# LORNA DOONE PARK—CITY PARKS FACILITY

<p><b>Owner</b> City of Orlando</p> <p><b>Applicant</b> City of Orlando Families Parks and Recreation Department</p> <p><b>Project Planner</b> Raquel Lozano, Planner II</p> <p><b>Updated:</b> April 13, 2026</p>	<p><b>Property Location:</b> 1830 W Central Blvd. Parcel ID: 34-22-29-9272-01-110. Generally located on the north of W. Church St., east side of S. Tampa Ave., south side of W. Central Blvd., and west side of S. Nashville Ave., west of S. Orange Blossom Trl. (±2.6 acres, District 5).</p> <p><b>Applicant's Request:</b> The City of Orlando Families Parks and Recreation Department requests a Conditional Use Permit to construct a ±6,000 sq. ft. Parks with public assembly areas and a detached ±1,000 sq. ft. maintenance garage at Lorna Doone Park.</p>	<p><b>Staff's Recommendation:</b> Approval of the request, subject to the conditions in this report.</p> <p><b>Public Comment</b> Courtesy notices were mailed to property owners within 300 ft. of the subject property on April 5, 2026. As of the published date of this report, staff has not received any comments from the public concerning this request.</p>

The City of Orlando Families Parks and

# SITE PLAN

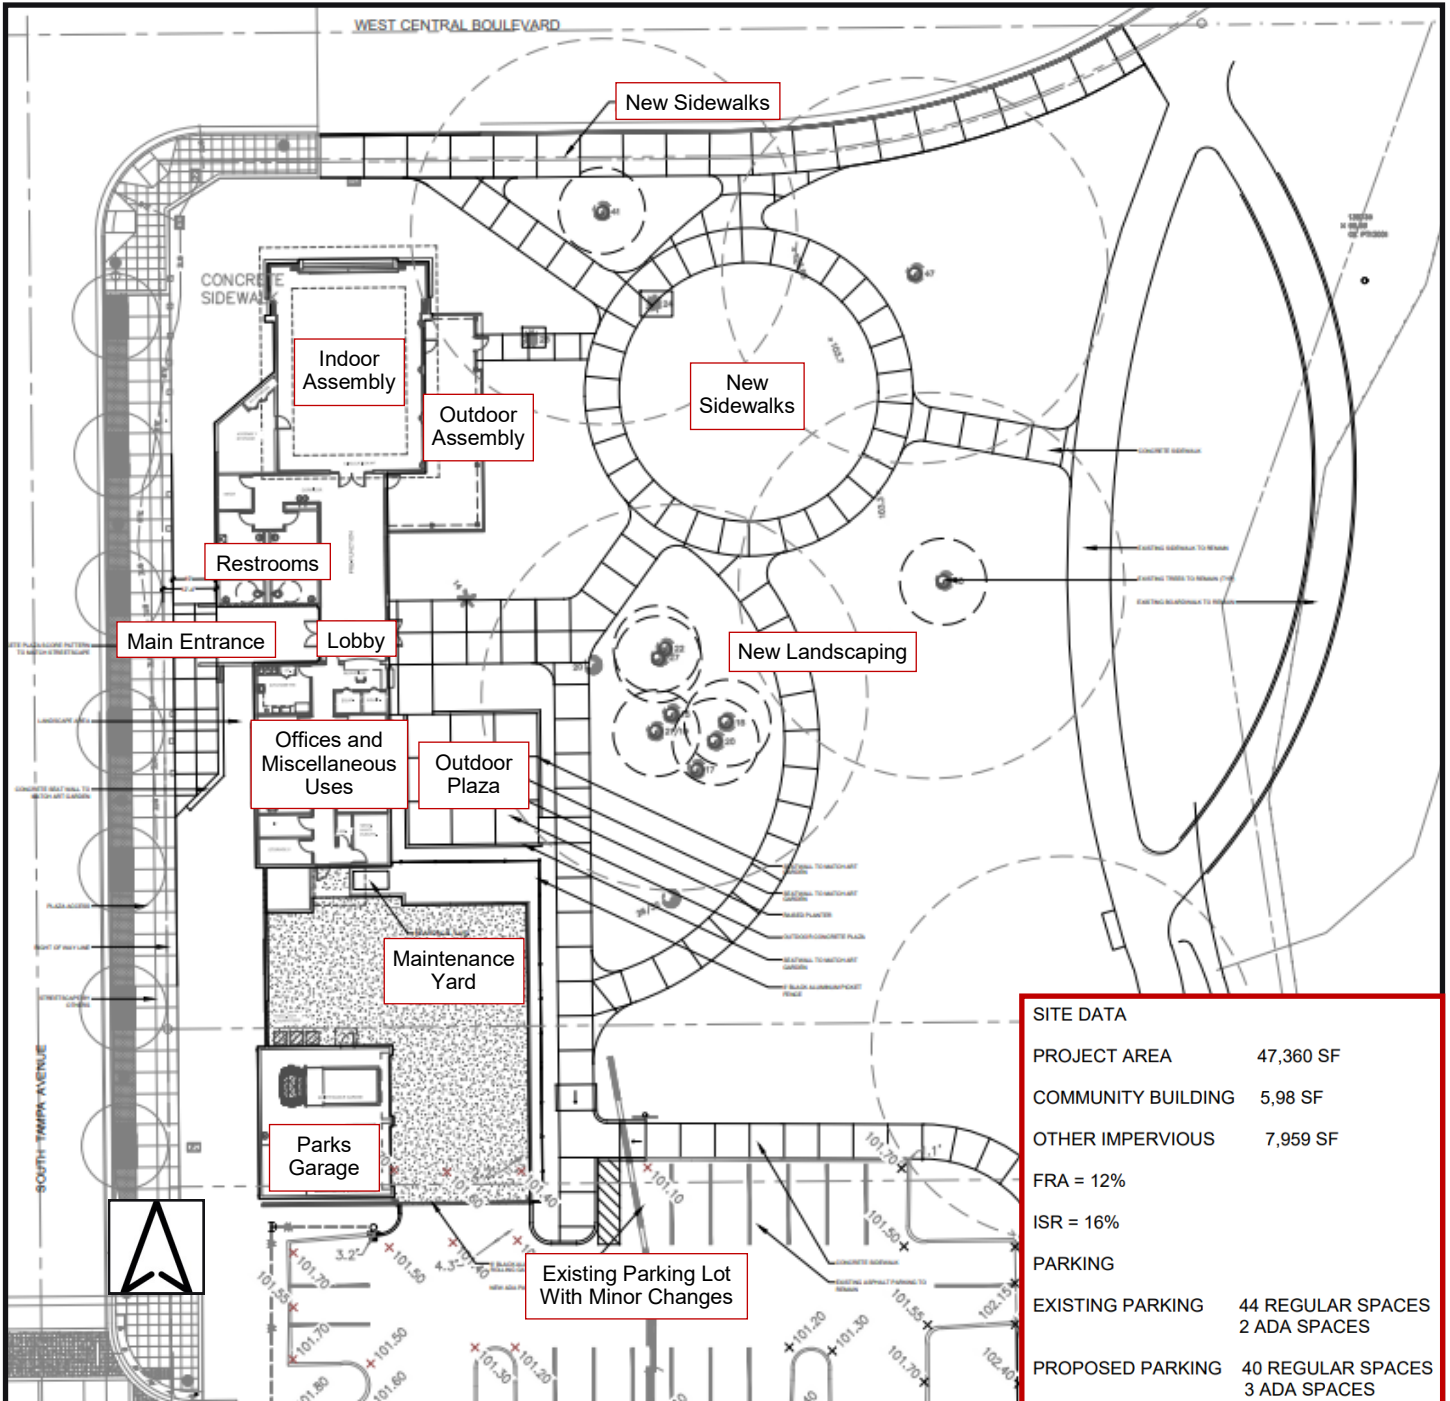
The concept plan provided does not show any parking for the new uses specified below. Be advised that curb/wheel stops will be required of all parking spaces per LDC Sec. 61.305.

The concept plan shows pedestrian connections from the existing parking area to the new building and use areas. As part of the conditions, Transportation Planning will require pedestrian safety signage to ensure proper vehicular movement without compromising pedestrian safety.

The site plan does not show any bicycle parking. As a condition of approval, the provision of micromobility enhancements, including bicycle parking, will be requested per LDC Sec. 10. This will supplement the transportation demands of the proposed use.

12. At the time of permitting, a stop bar and an R-1 stop sign is required to be installed at the maintenance yard exit to the existing parking lot.
  13. An Auto-Turn analysis using the largest anticipated design vehicle (delivery vehicle, Fire/EMS vehicle, solid waste collection) must be provided at the time of permitting to demonstrate adequate maneuverability within the site. The site plan should be updated to demonstrate that access for these vehicle types can be undertaken in a safe manner without conflicting with other vehicles, pedestrian, or bicycle access.

# LANDSCAPE PLAN

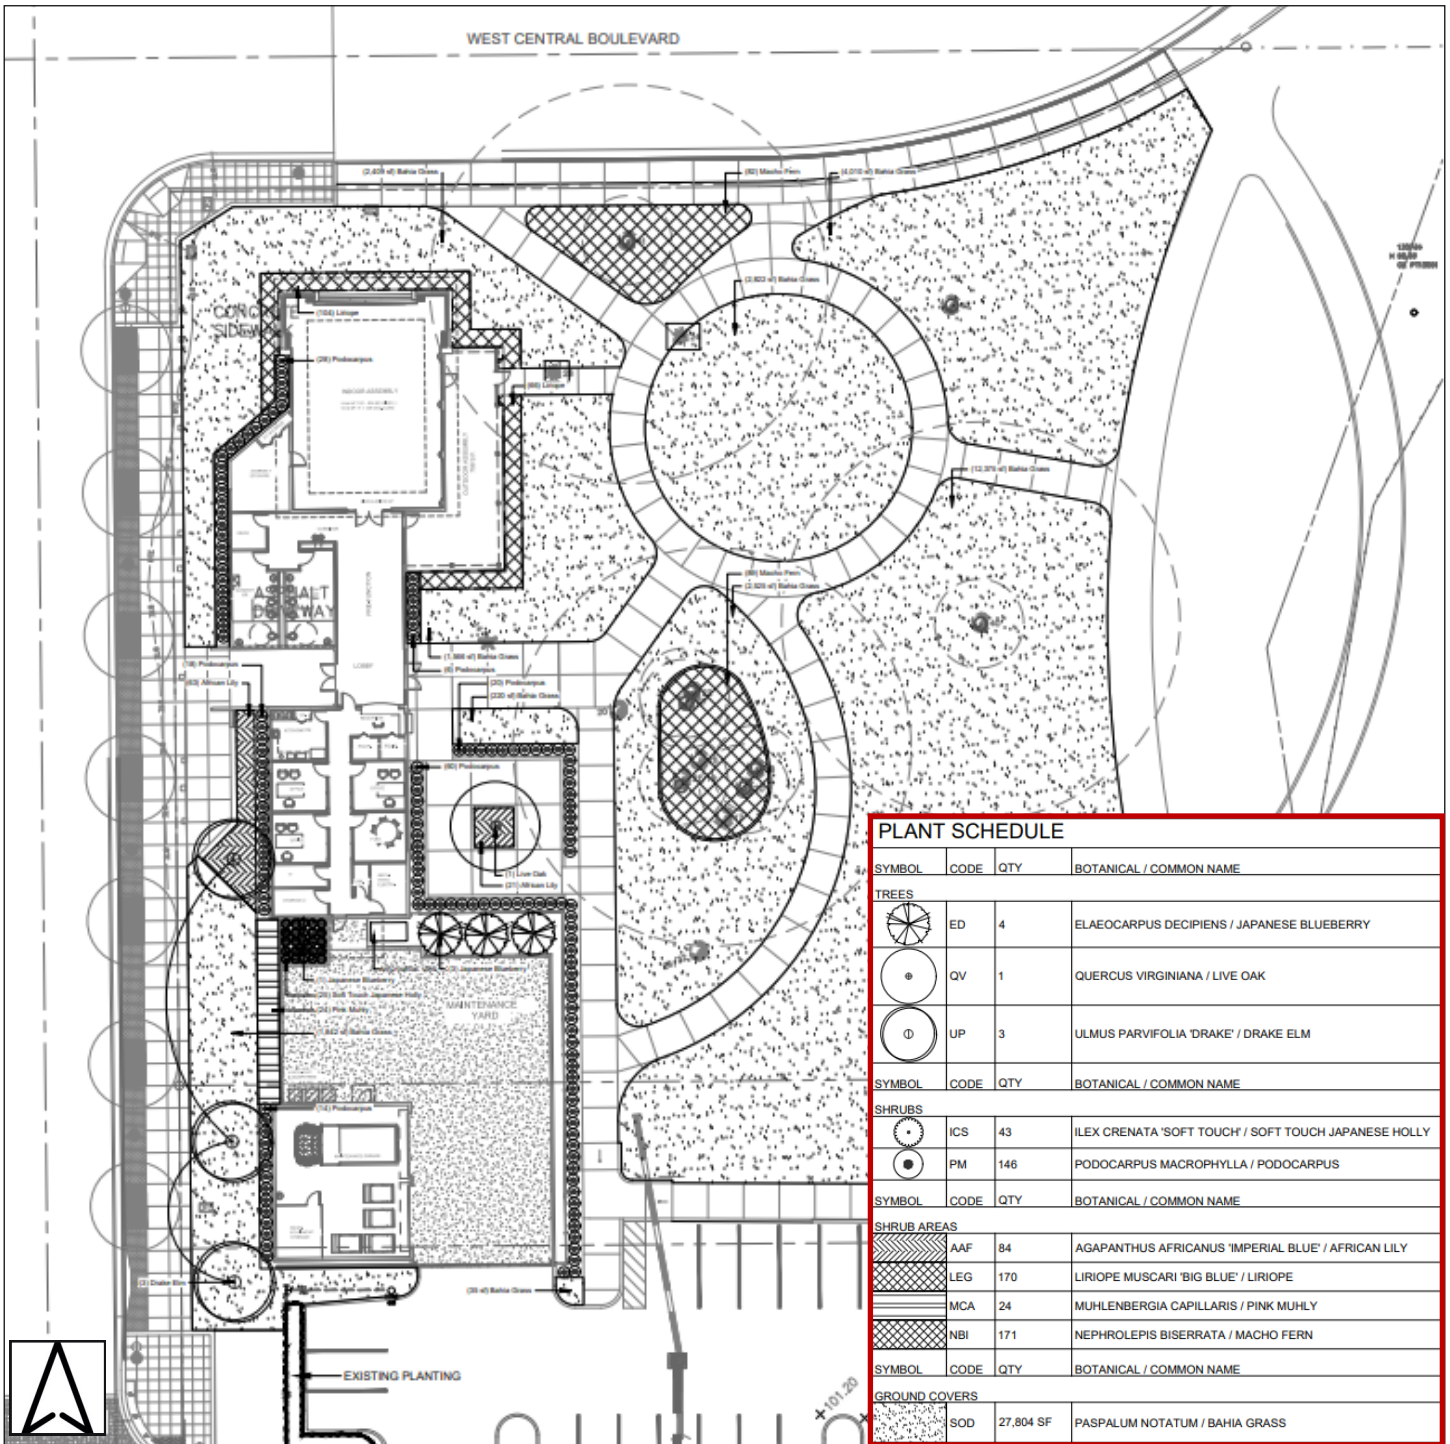
The Land Development Code requires the City Parks Department to install landscaping per Section 61.312. The City Parks Department proposes to install eight new trees, three of which are located along S. Tampa Ave. and the other trees would be installed east of the new building. Two trees may be removed in the process, dependent upon the location of the nearby sewer pipe. Additionally, hundred of new shrubs and sodding will be installed at the site. At the time of permitting, the applicant must provide a Landscape Worksheet to show compliance with code. Any tree removals will require a separate permit for City approval.

5. A landscape worksheet is required to be submitted at the time of permitting. All landscape plans must achieve the Minimum Required Landscape Score (MRLS) required for the proposed type and intensity of development and meet the requirements of Chapters 60 and 61, Orlando City Code. A spreadsheet showing compliance with the Minimum Required Landscape Score must be included with the plans. A digital spreadsheet form is available at <http://www.cityoforlando.net/city-planning/landscape-code/>
